# GRADING AND EROSION CONTROL PLANS FOR WALDEN SANITATION DISTRICT WASTEWATER TREATMENT PLANT PROJECT EL PASO COUNTY, COLORADO MARCH 2026

PCD PROJ. NO. : PPR2538

SHEET TITLE: LAGOONS CLOSURE PLAN		
PROJECT NUMBER: #3774	SCALE: 1"=100'	SHEET: C11

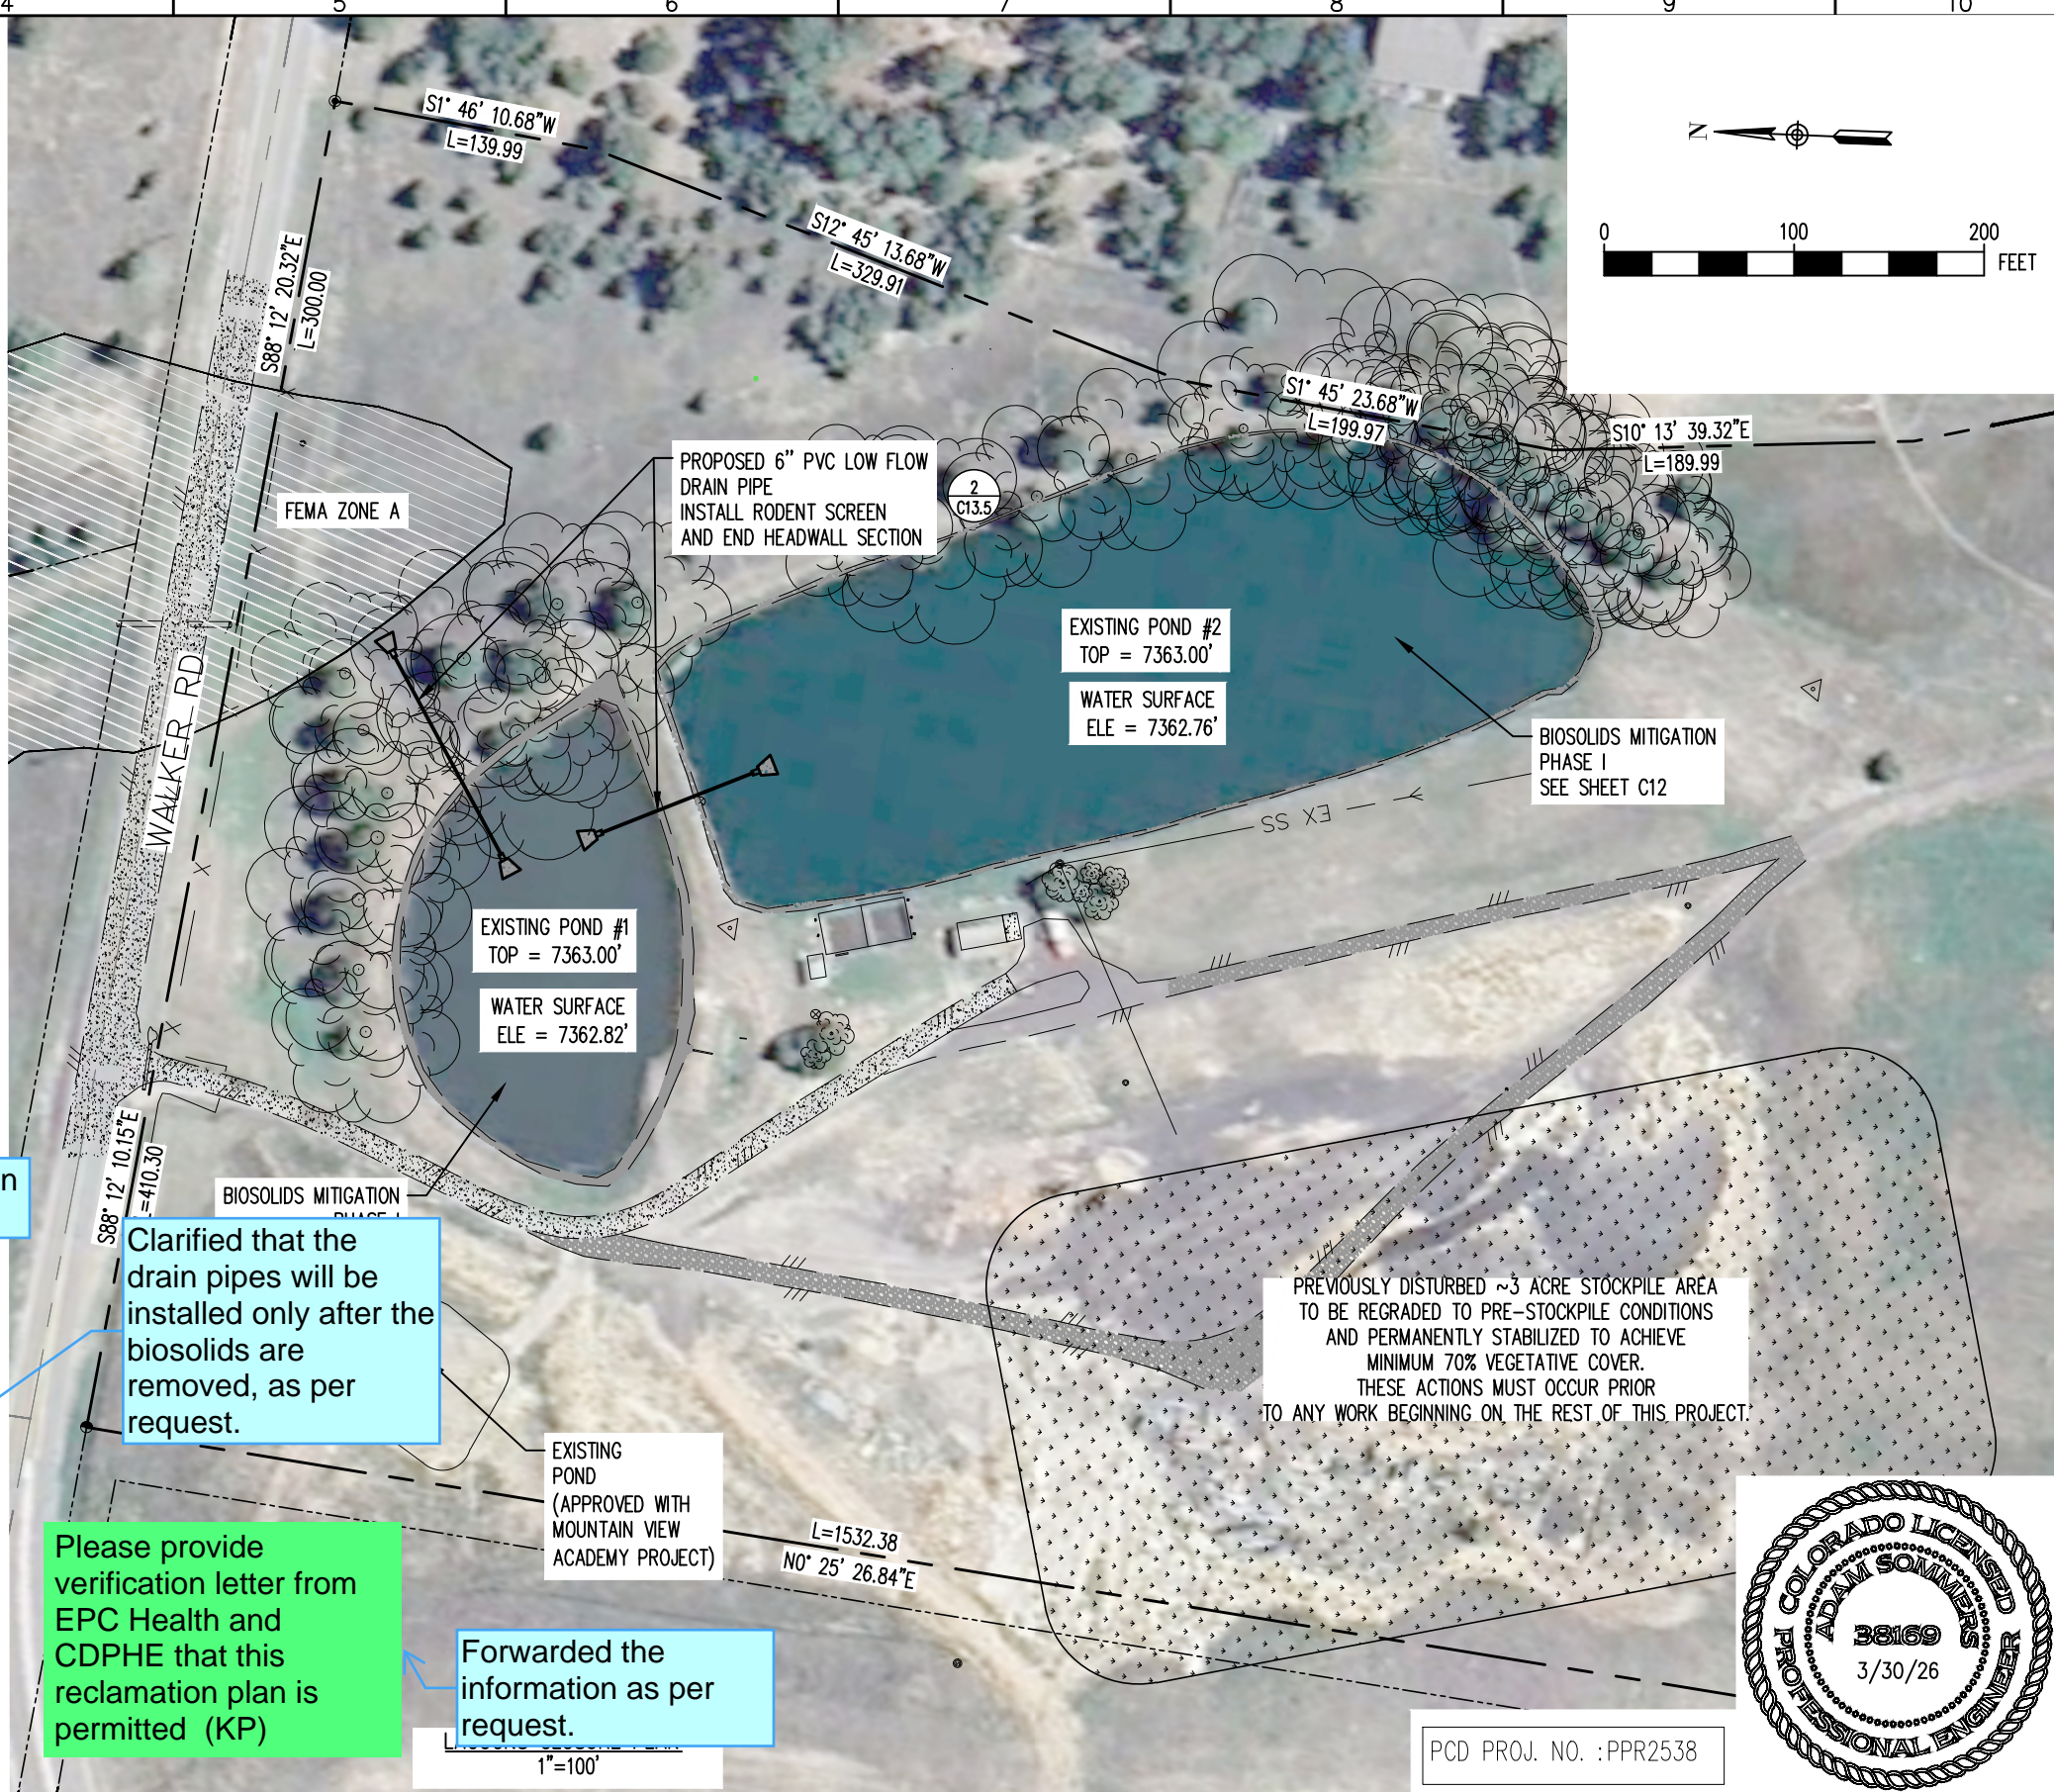
Can this information be added to the Pond Reclamation plan document

Show stockpile area on GEC plan

Clarify when drain pipes will be installed

Please provide verification letter from EPC Health and CDPHE that this reclamation plan is permitted (KP)

The pond water will flow through the proposed WWTP and be discharged appropriately. Once the biosolids are removed, these two new storm sewer lines will be installed and the ponds will drain via gravity from there. They will be capped until ponds are revegetated. Added this additional information to notes on "Lagoons closure plan" sheet

SHEET TITLE: EROSION CONTROL DETAILS I		
PROJECT NUMBER: #3774	SCALE: N.T.S.	SHEET: C13

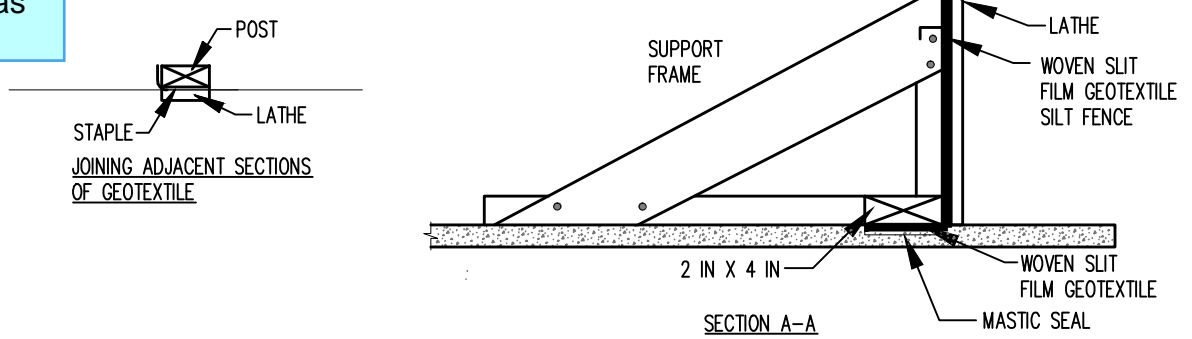
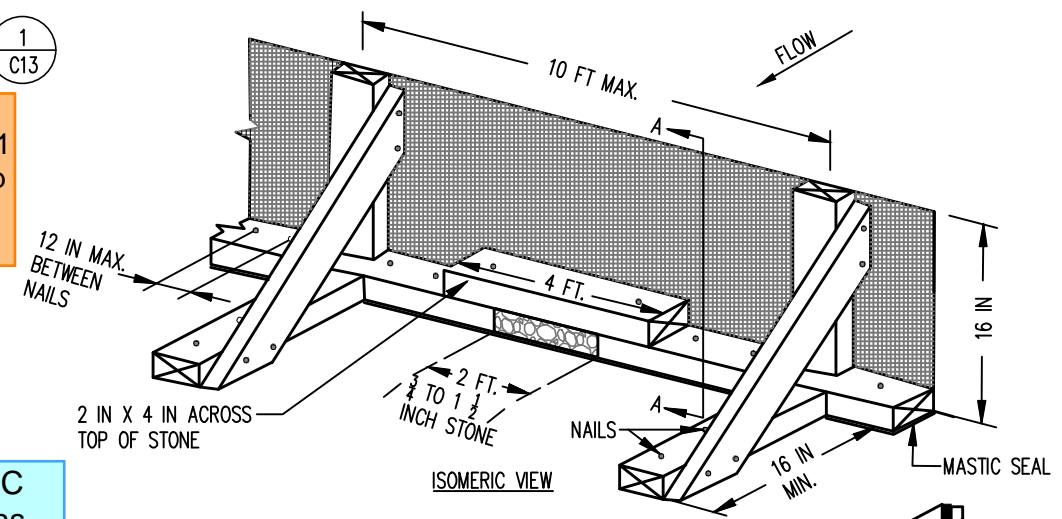
Replace with EPC approved VTC detail (VT-1 and VT-2 in DCMv2, Chap 3.3) or revise to be 75ft min length.
